## **PLANNING BOARD AGENDA FOR JANUARY 13, 2026 - 7:00 PM**

1. **Salem NIM, LLC Site Plan** – Public Hearing for change of use for 19,960 sq. ft. restaurant and entertainment use with conditional use permit for reduced parking and additional signage at 11 Mall Road, Map 107, Lot 11154. Continued from 12/9/2025.

Below please find our responses comments discussed in our December 9 2025 meeting and at the PB meeting. Below please find each comment followed by our response in **bold**.

# LYONS GROUP RESTAURANT AT THE MALL AT ROCKINGHAM PARK PLANNING BOARD SUBMISSION

M101 | GARBAGE TRUCK MOVEMENT PLAN

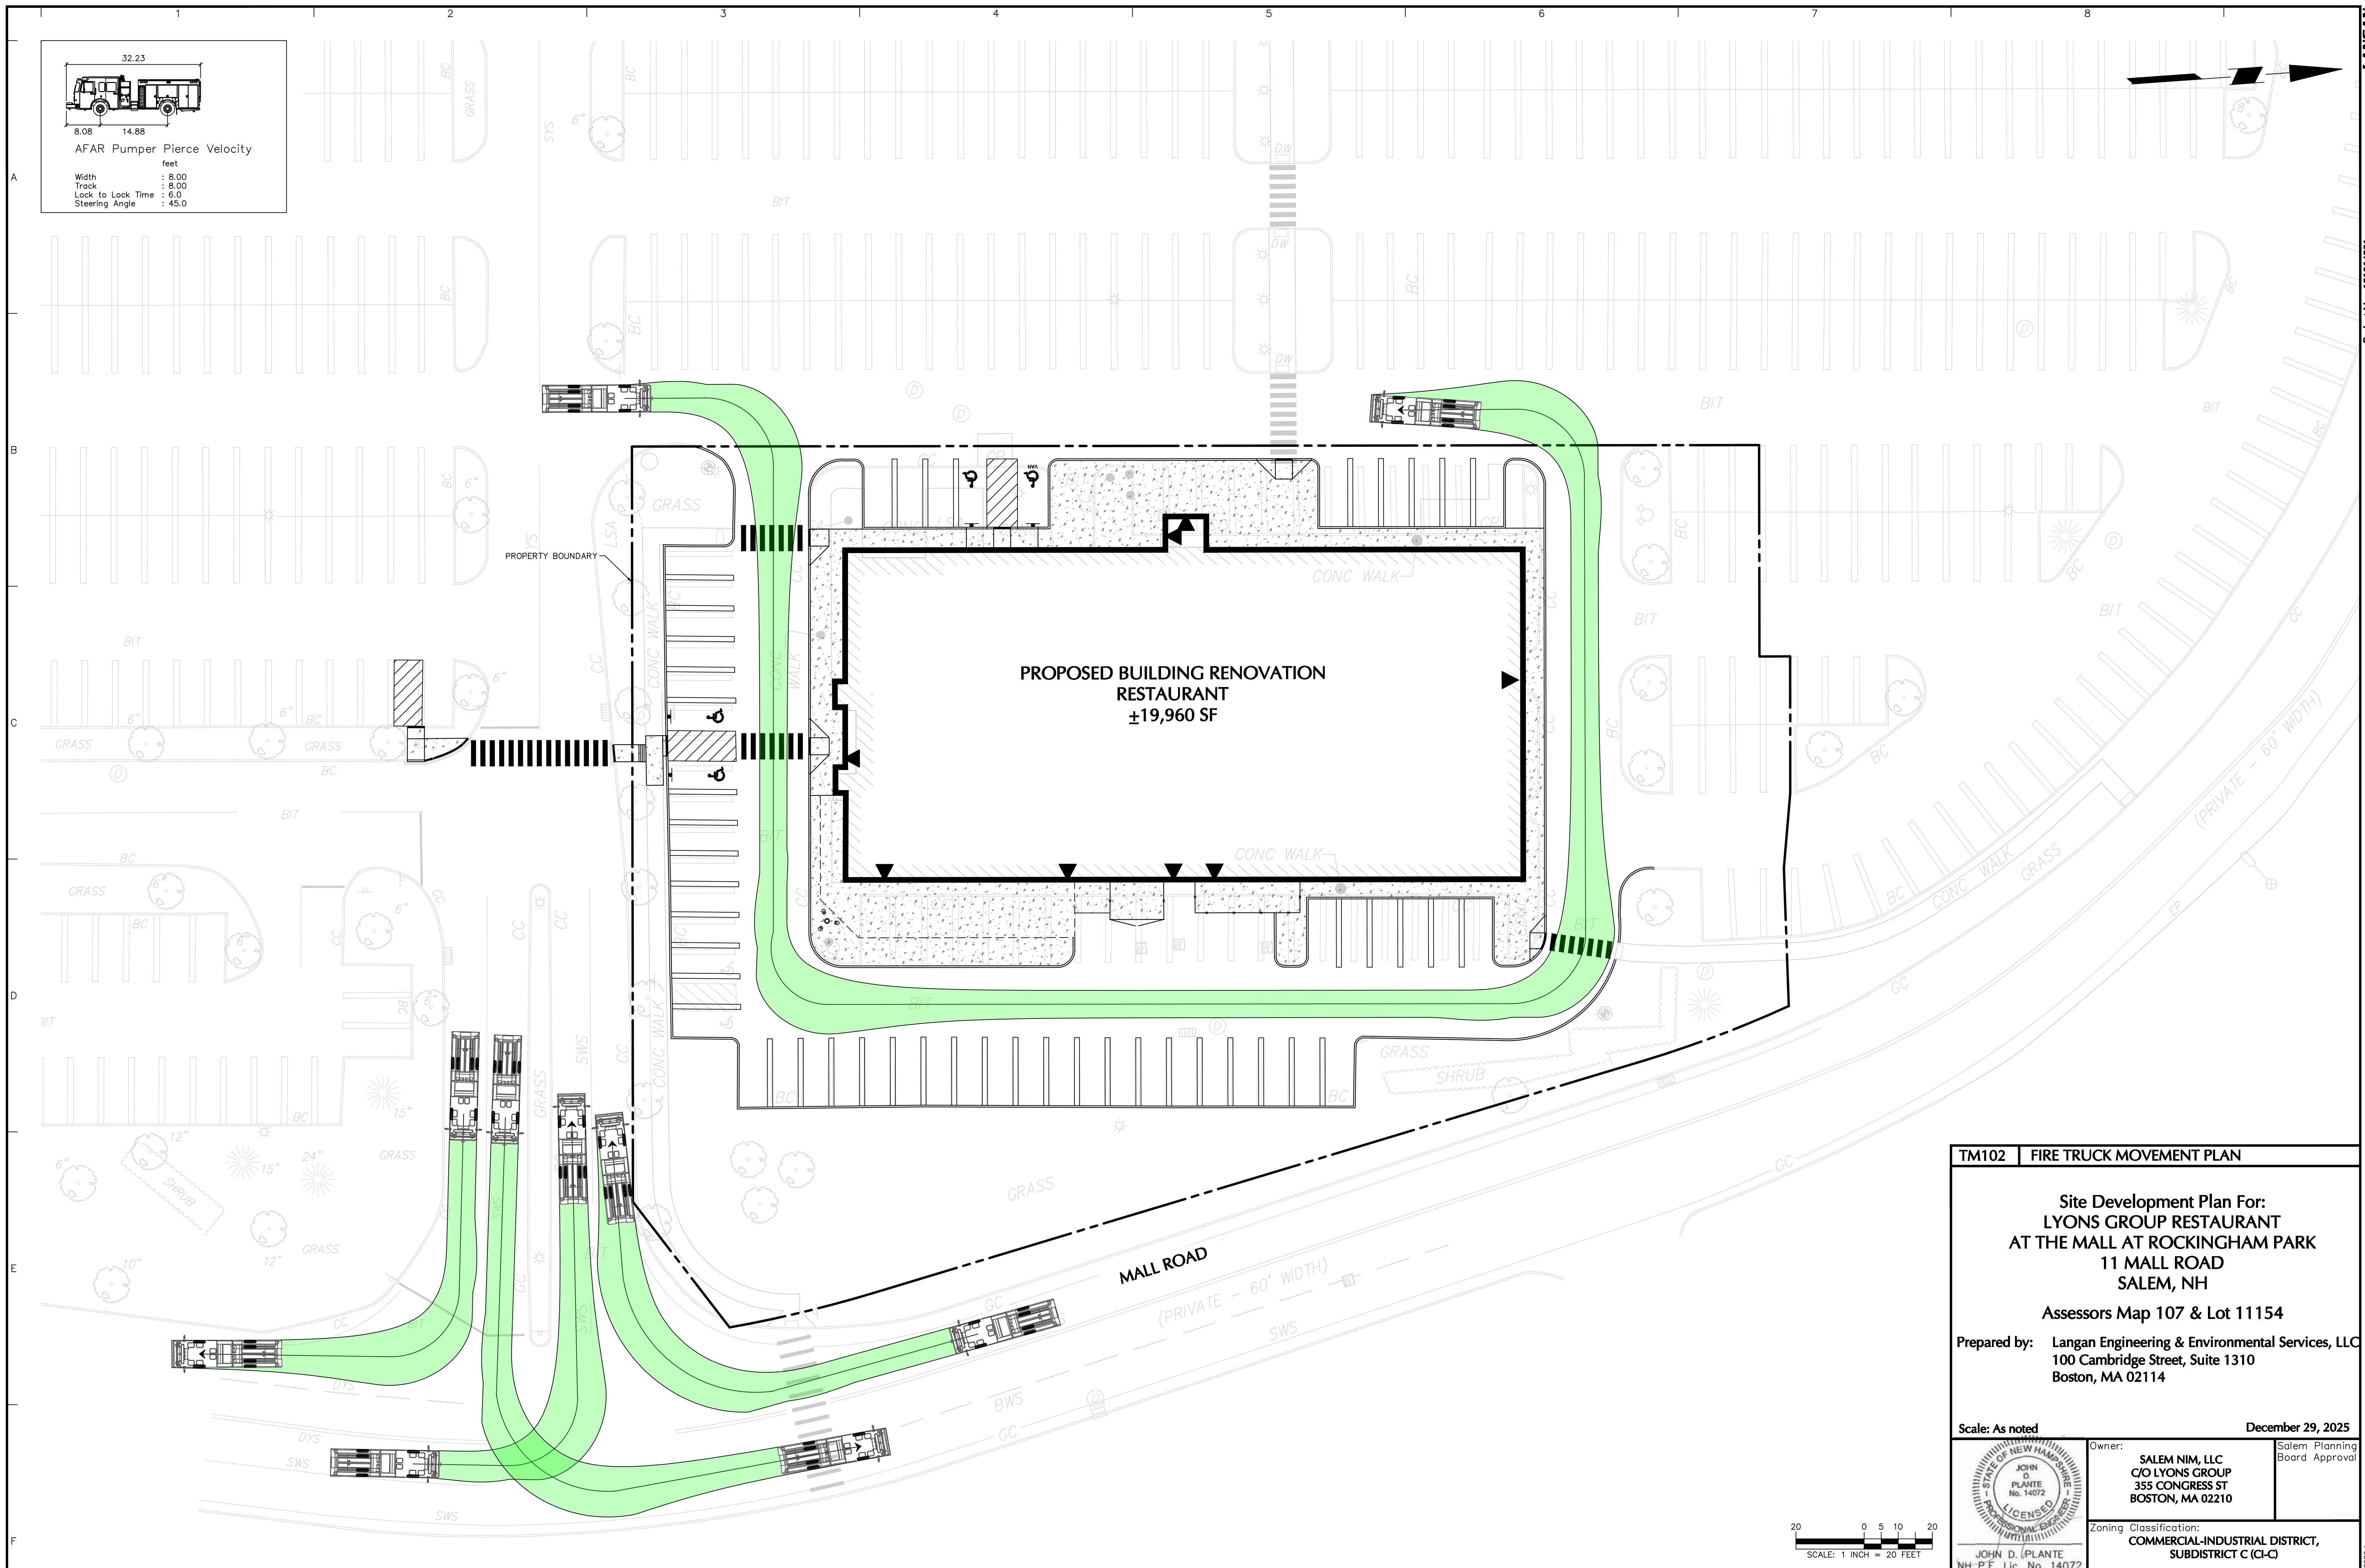
Site Development Plan – A vehicle tracking analysis should be prepared that demonstrates: 1) compatibility with Salem fire apparatus, and 2) how the dumpsters will be serviced. According to Sheet CS101, 68 spaces are proposed within the subject site. It should be noted that the peak parking demand estimates range from 158 to 395 occupied spaces. This means that there is the

COMMENT RESPONSE: Truck turning plan has been added to the set on TM101.

**COMMENT RESPONSE: Vehicle turning movement demonstrations are provided on Sheets TM101 and TM102. The 85<sup>th</sup> percentile (peak) parking estimates for Loretta's and Game On! are 266 spaces, which is 71% of the available parking spaces within Lot C1.**
